Subject: **MHI's Amended Response to US-APWR DCD RAI No. 760-5576 Revision 0 (SRP Section 09.02.02)**

Amended Response to Request for Additional Information
No. 760-5576 Revision 0

RAI NO.: **NO. 760-5576 REVISION 0**

QUESTION NO.: 09.02.02-82

Figure 1 Schematic of Test Apparatus

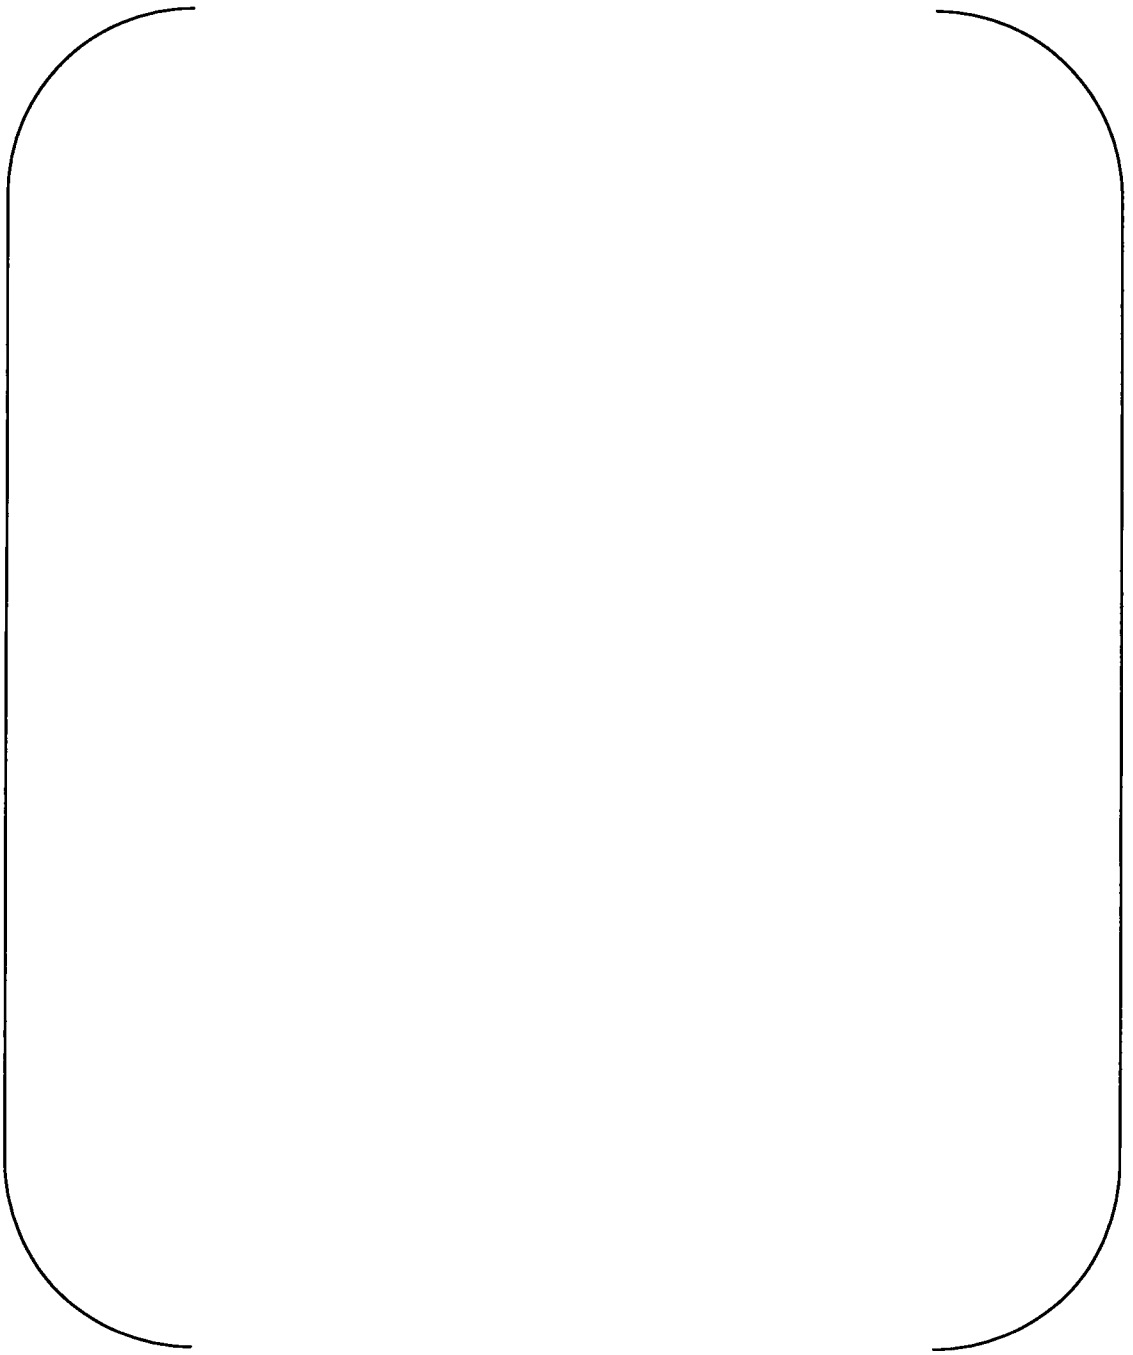
5. A Topical Report for the RCP seal design has not been provided to the staff regarding seal testing to support the three seal design and to support the 0.2 gpm seal flow rate during SBO. This information should be provided to the staff.

A schematic of the test apparatus is shown in Figure 1.
The No. 2 seal to be tested is attached on the upper side. No. 1 seal is not equipped at upstream of the No. 2 seal so the total pressure is applied to the No. 2 seal.
The apparatus has its own seal assembly at the lower side.

SBO condition was simulated in the test. Although AC supply to RCP motors immediately stops at the beginning of SBO, the rotation of the RCP shaft gradually stops because of inertia of a flywheel. In the test the shaft rotation speed was kept at 1200 rpm for the first 1 minute and it was gradually reduced to zero in 5 minutes and kept at zero for one hour.

The test result is shown in Figure 2. It was confirmed that the leak rate is less than 0.2 gpm when the rotor is rotating and less than 0.1 gpm after rotor stop.
